# Report on WINDOW 6 / THERM 6 NFRC “Pilot” Training Venetian Blinds

*Submitted by Christian Kohler and Robin Mitchell  
Lawrence Berkeley National Laboratory (LBNL)*

On May 4, 2009, LBNL hosted a “pilot” webinar training session for NFRC simulators about using WINDOW 6 and THERM 6 to model venetian blinds and fritted glass.

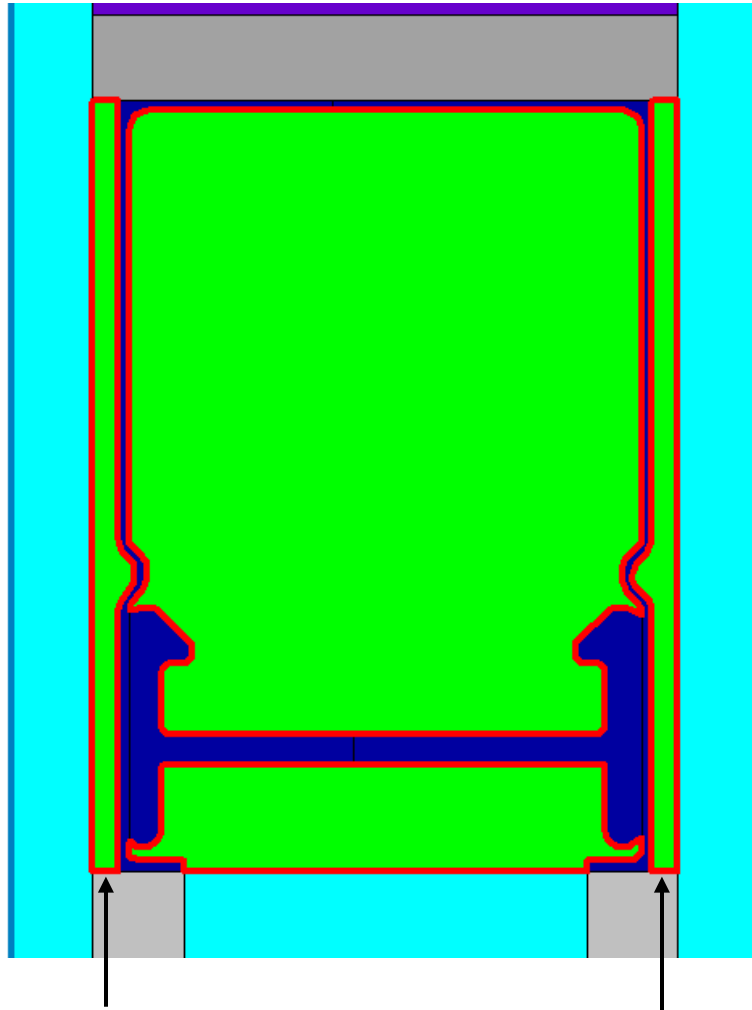
1. Establish a rule about when cavities associated with the Venetian blind are linked to the glazing system cavities, and when they are set to frame cavities. LBNL proposed a 2.5 mm rule:

If the “throat” between a cavity and a glazing system cavity is  $\geq 2.5$  mm, link it to the glazing system cavity. Otherwise, define it as a frame cavity.

This is an example where the cavities on either side of the top rail would be defined as frame cavities because the “throat” where that cavity meets the glazing system cavity is  $< 2.5$  mm.

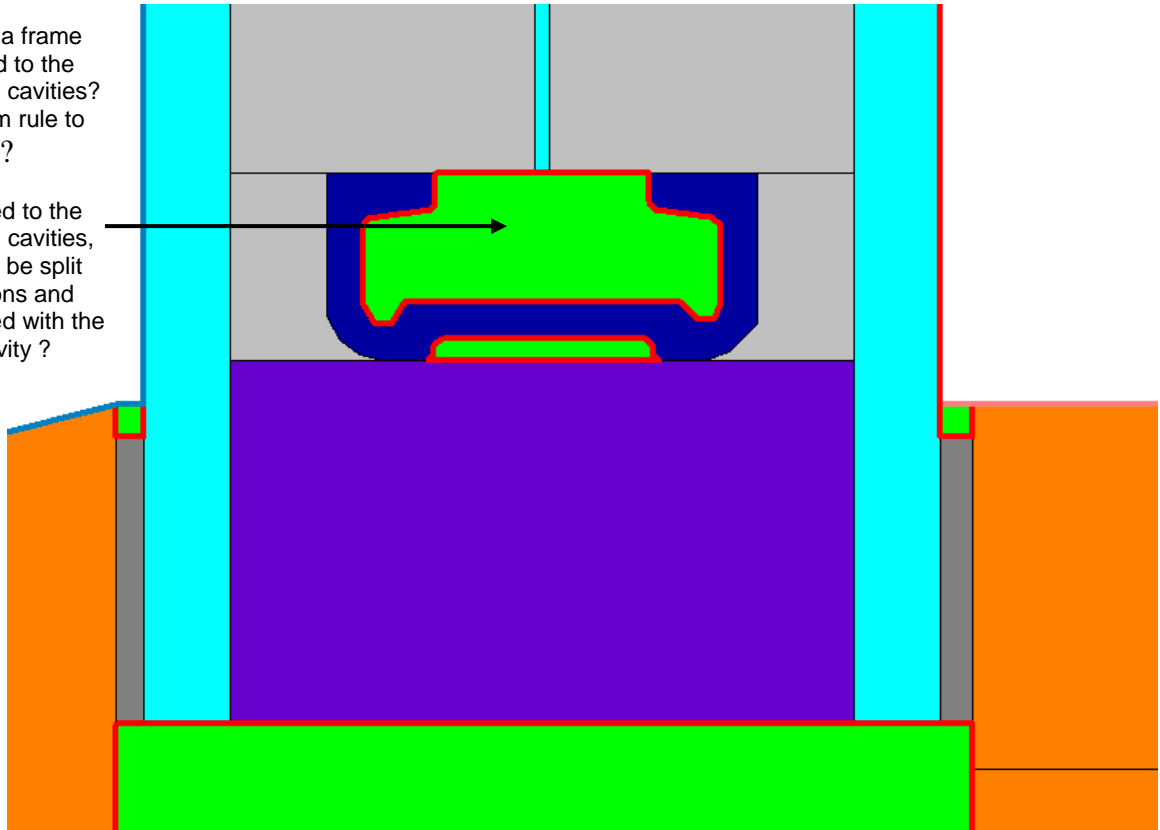
2. What to do with the cavity in the closed Venetian blind head and sill examples, where the blind does not go into the head rail or bottom rail – should the cavity be a frame cavity or linked to the glazing system cavities and if so, which ones (or both, ie, dividing up the rail cavity).

Should this be a frame cavity, or linked to the glazing system cavities? Use the 2.5 mm rule to determine this ?

And if it is linked to the glazing system cavities, does it need to be split into two polygons and each associated with the appropriate cavity ?
